PUBLIC SERVICES UTILITY PERMIT APPLICATION - Permit Fee of \$100.00

Date of Application: 9-21-21 Permit No: ATT - 0014 REV Permit Expiration Date: ~~10/15/21~~ 6/30/22

ATT PERMIT ADDENDUM #2

Project # A022PBP **State:** IL
County: DUPAGE
Township: DOWNERS GROVE NORTH
Municipality: HINSDALE
Quarter Section: 1 & 12

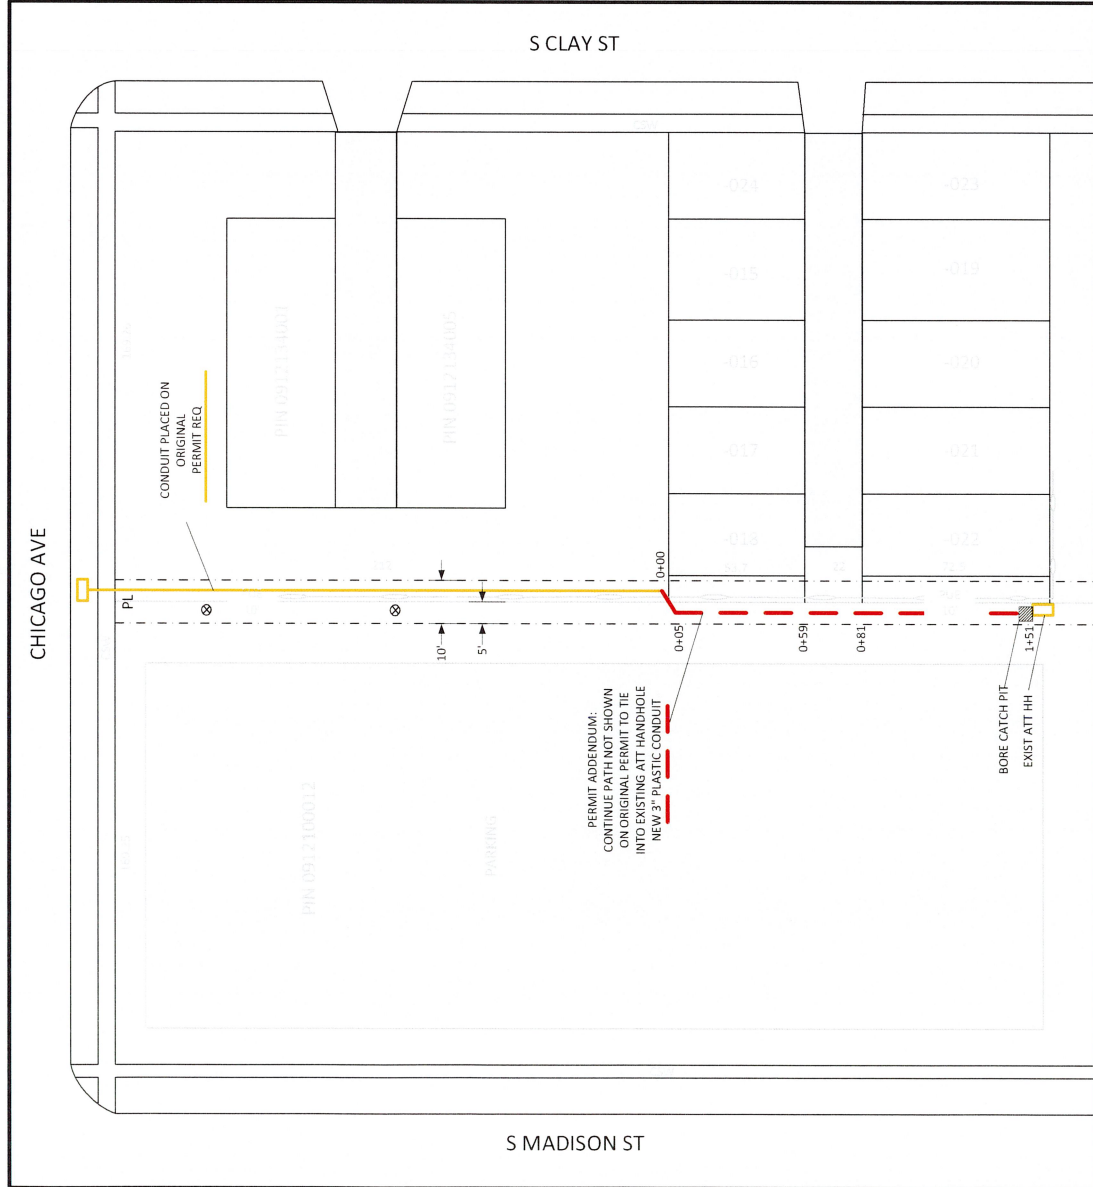
ATT TO CONTINUE BORE AND
PLACE 1-3" PLASTIC CONDUIT
151' ALONG SAME PATH ON
PREVIOUS PERMIT TO TIE INTO
EXISTING ATT HANDHOLE

ALL RESTORATION AND
REQUIREMENTS OUTLINED IN
PREVIOUS PERMIT WILL FOLLOW
THIS ADDENDUM

PROPOSED WORK AREA

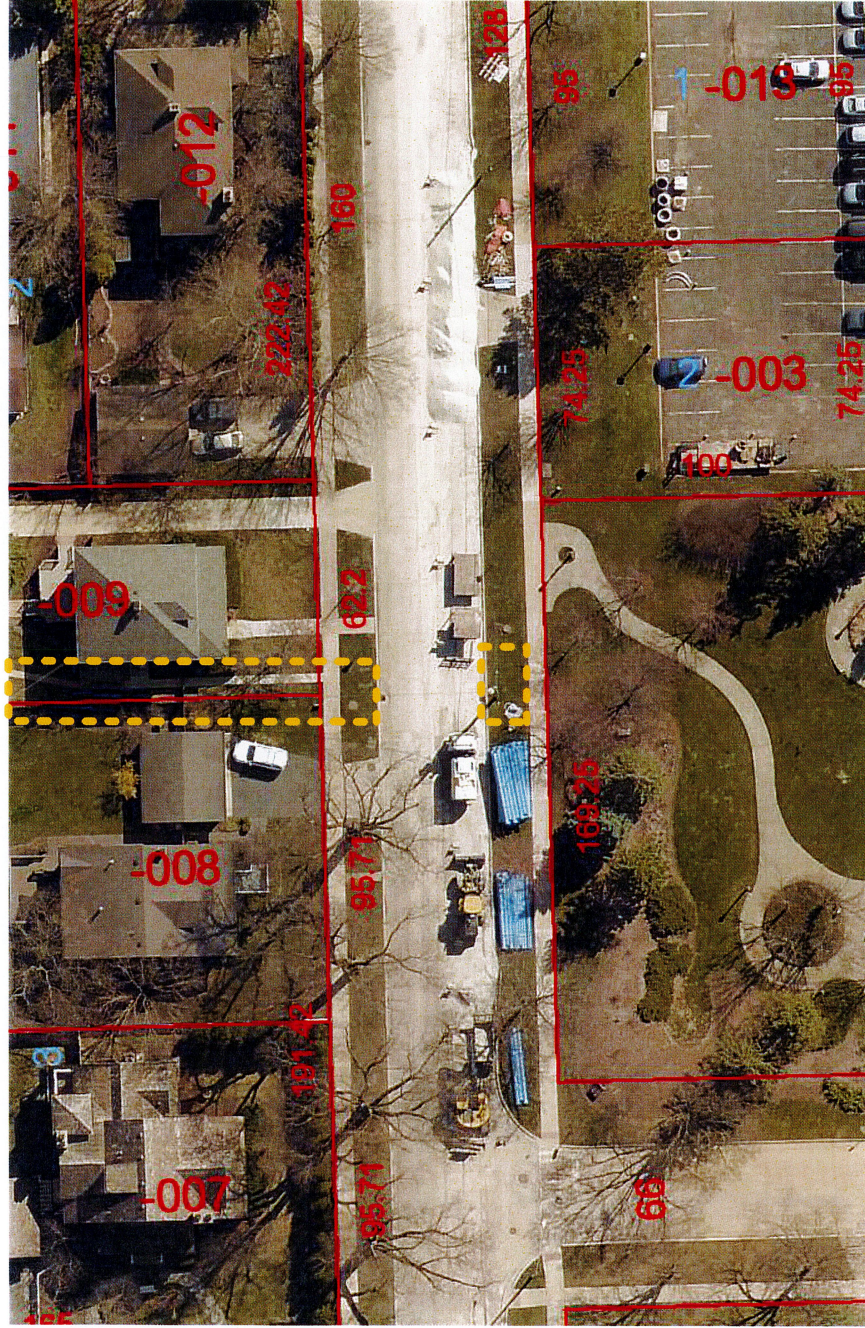
DUE TO LIMITED OVERHEAD CABLE PLACEMENT OPTIONS AND COMED CLEARANCES ATT HAS DECIDED TO PURSUE A BURIED OPTION FOR ATT FIBER CABLE PLACEMENT

LOC1-WORK BEGINS IN ROW GRASS AREA AT MH188B
0+00 EAST 5' THEN TURNS NORTH 101' TO 1+06 PLACING
1-2" PLASTIC CONDUIT. PLACED VIA DIRECTIONAL BORE.
FLAGGING MAY BE REQUIRED ON CHICAGO AVE WB LANE
DURING BORE. PROPER DOT SIGNAGE AND FLAGGERS TO
BE USED.

LOC2- EXISTING CONDUIT WILL BE ACCESSED AND REDIRECTED UP POLE LOCATION IN SOUTH ROW OF CHICAGO AVE. THIS PROVIDES A PATH WITHOUT HAVING TO OPEN CUT ROADWAY
